Arkansas Nuclear One - Unit 2

CEN-157(A)-NP

Response to Questions
on Documents Supporting
The ANO-2 Cycle 2
License Submittal

July 1981

Figure S-1

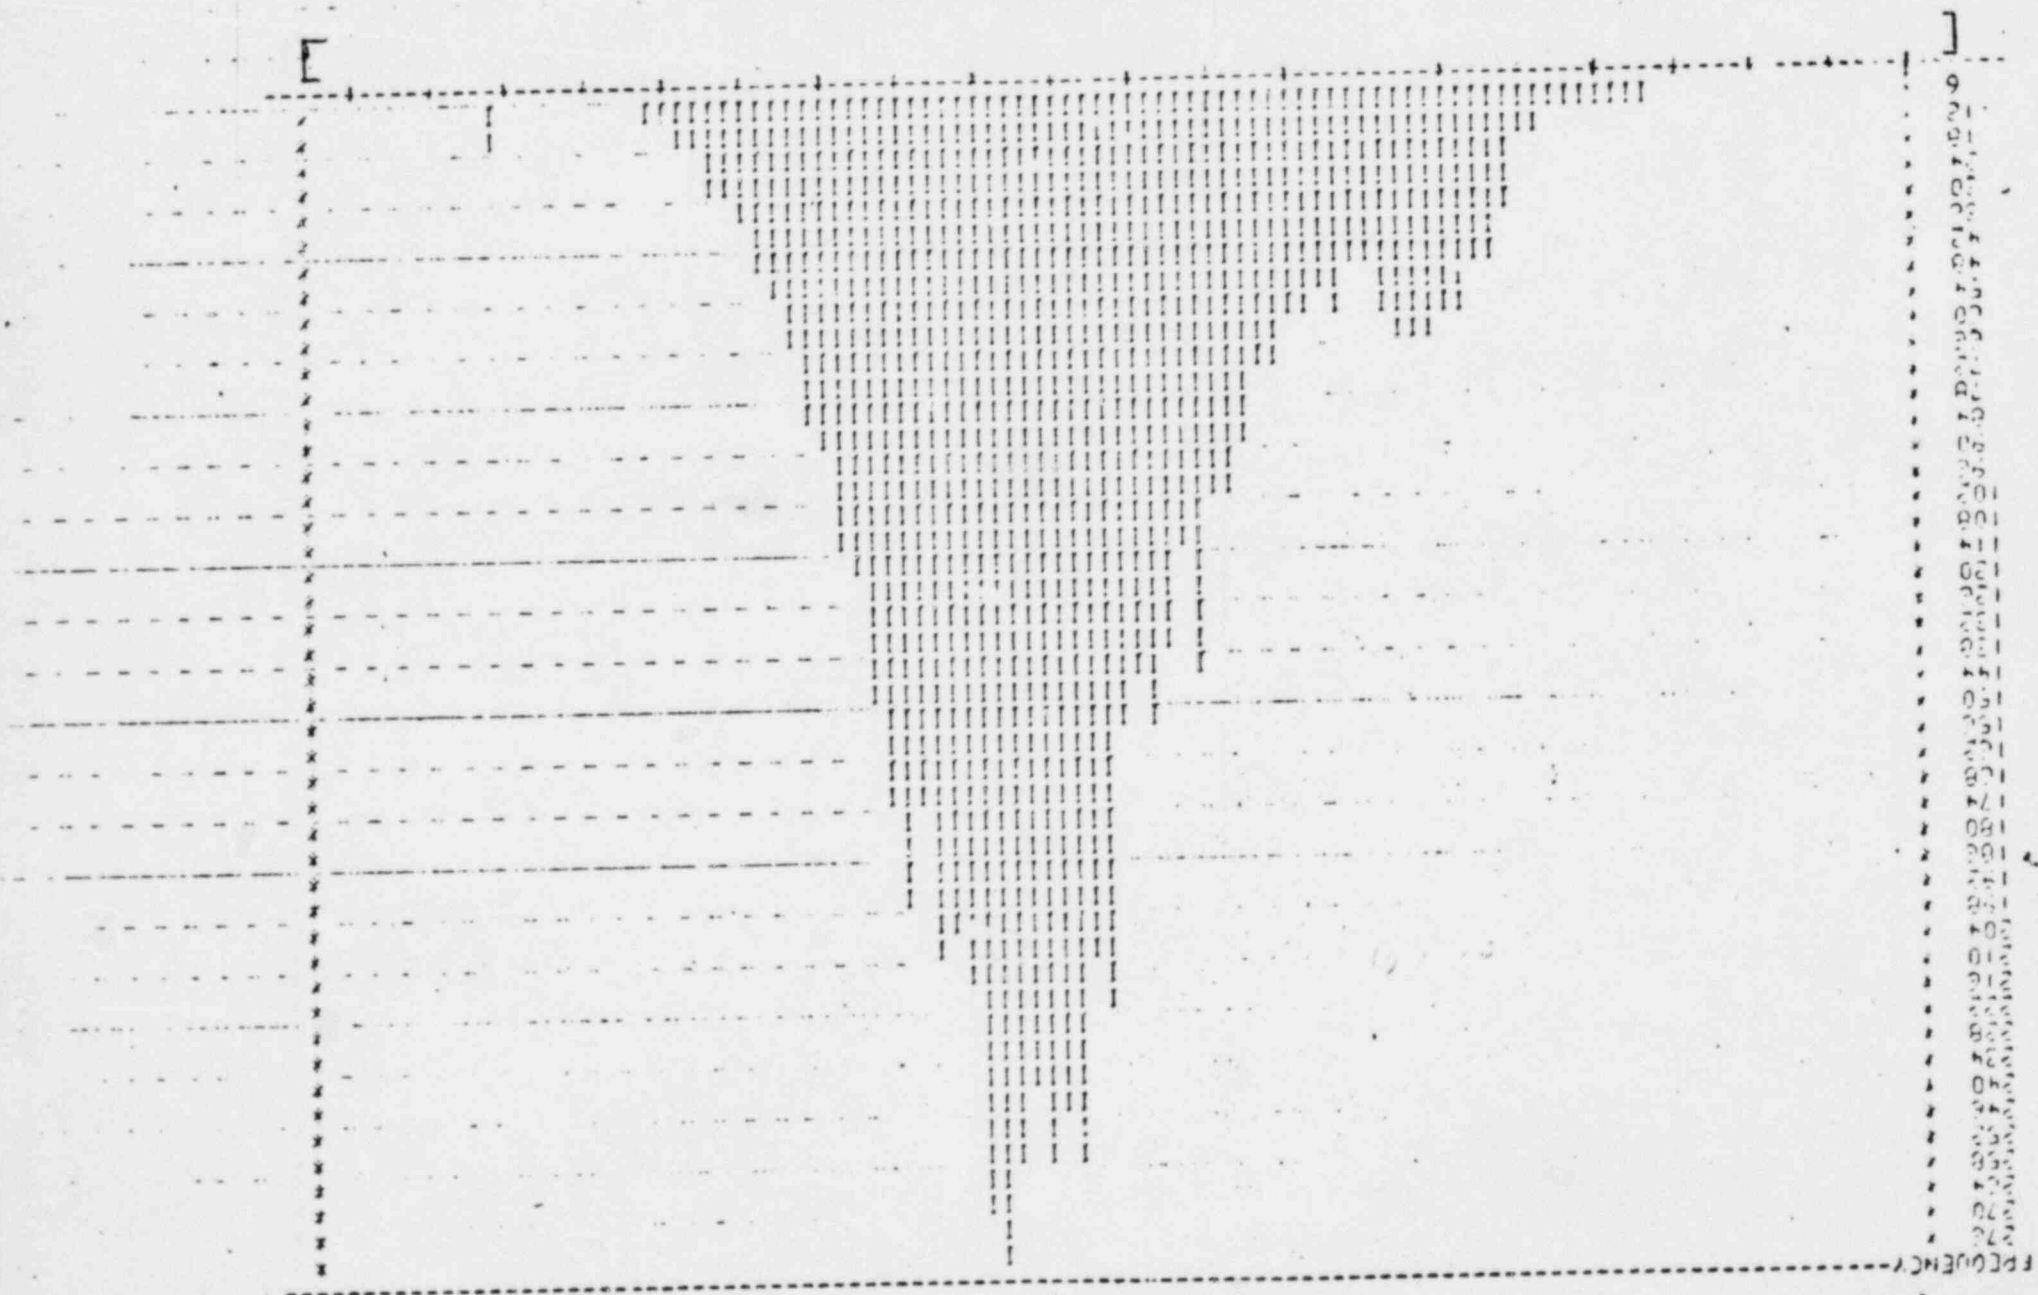
Question 492.15

How is the value of power uncertainty factor of [] obtained for DNBR calculation?

The value of the algorithm uncertainty factor (E) in CEN-143(A)-P has been changed. The new value which is installed in the CPC software is []. The value of [] is the 95/95 one sided tolerance factor determined from the distribution of the ratio of CETOP-2 to CETOP-D overpower margins (see Figure S-1). The change in the E value is due to the following reason:

The CETOP2 code is written to use the hot channel peaking factor (hot channel power/core average power) as input. In the original analysis this input was used and the CETOP2 vs. CETOP-D analysis yielded a 95/95 tolerance factor of []. During a quality assurance review of the CPC module interfaces it was discovered that the CPC power algorithm calculates a [] peaking factor, rather than the [] peaking factor, for use in the static DNBR calculation. The [] peaking factor is [] than the [] peaking factor.

This input discrepancy was discovered late in the software design process and therefore an algorithm change to correct the discrepancy was not feasible. Instead, the uncertainty assessment was repeated for CETOP2 with the input changed to [] to be consistent with the input to the on-line algorithm. The result of the new analysis was that the error distribution shifted by almost []. The new value of [] reflects the actual CETOP-2 on-line algorithm performance relative to CETOP-D.
